Product Change Notification

S12 CO2 sensor. Article number: 012-0-0001

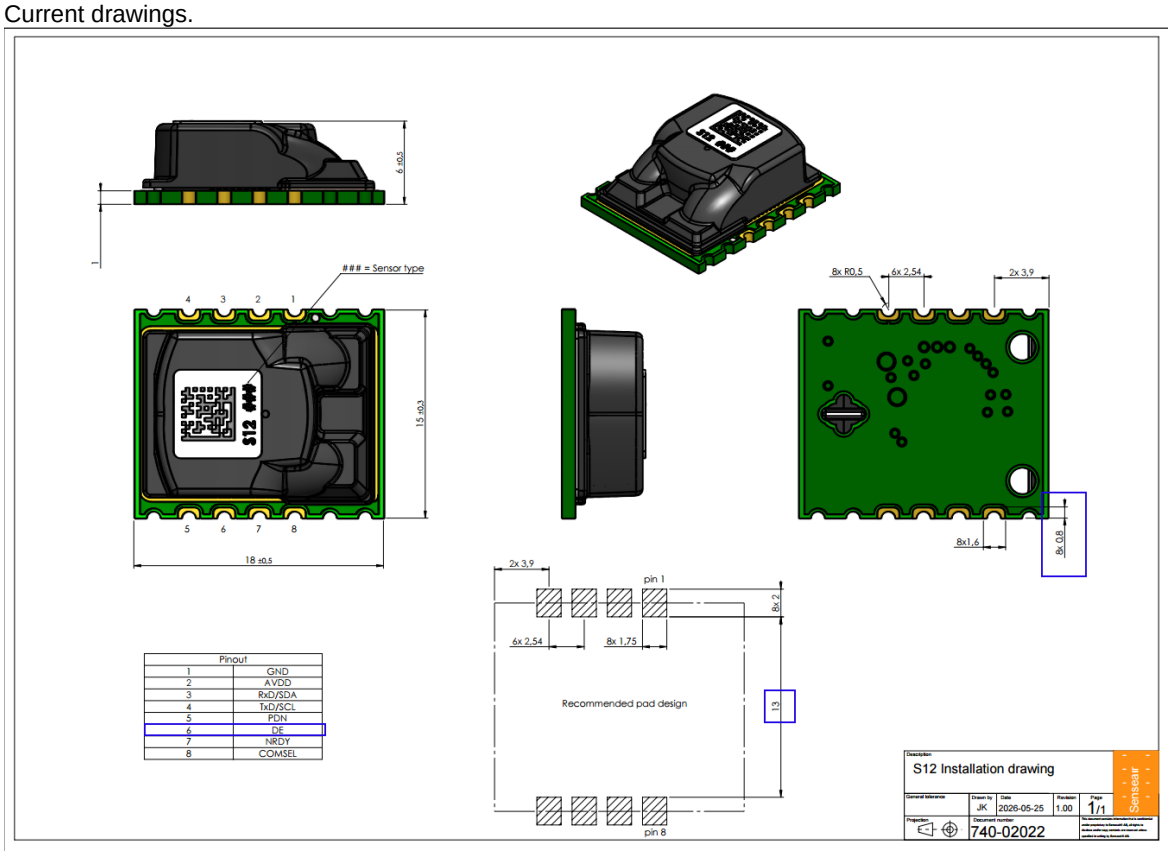
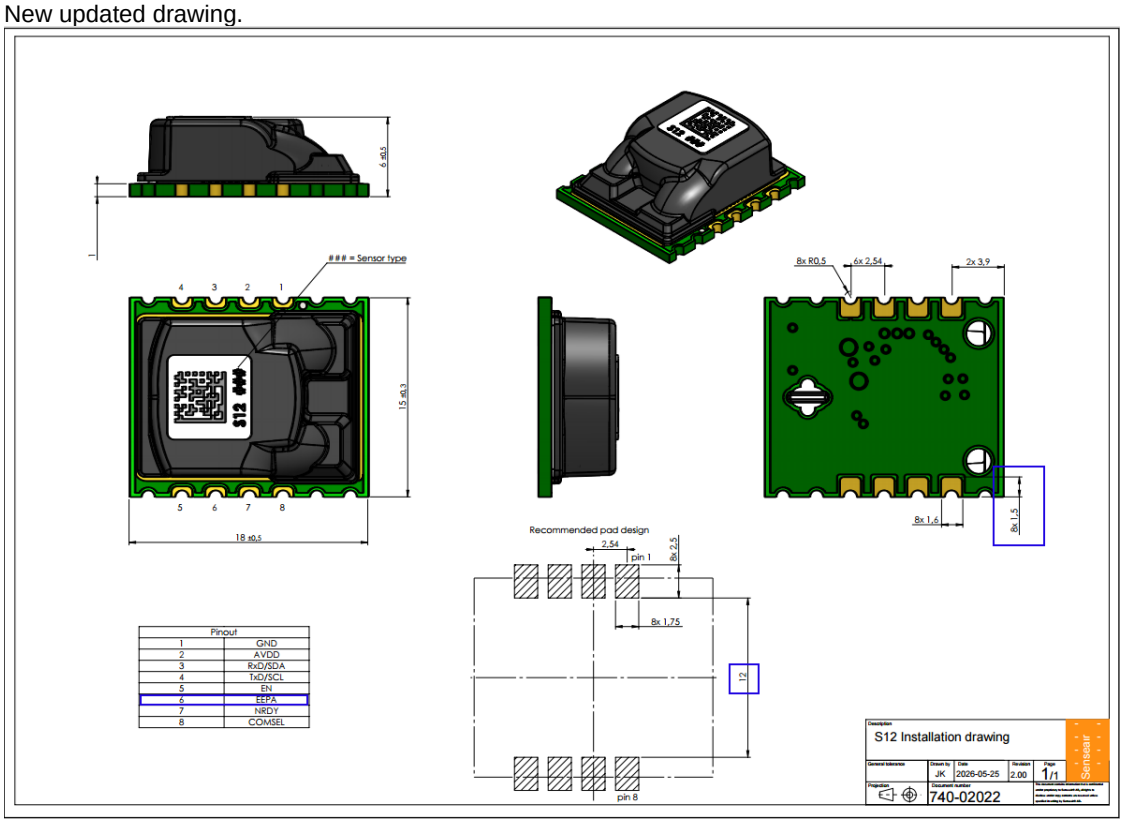
1. The function of Pin 6 (DE, communication Direction pin Enable) has been changed. The DE has been replaced to an EEPA (EEPROM Access). The EEPA output provides you with the EEPROM status when a write operation is in progress.

2. The solder pad layout has been increased by 0.7mm (from 0.8mm to 1.5mm).

Updates are marked in blue in the drawings below.
The soldering pads are visibly larger.
Product specification (PSP15871) and S12 CO2 Reflow soldering instructions (TDE16239) will be updated accordingly.
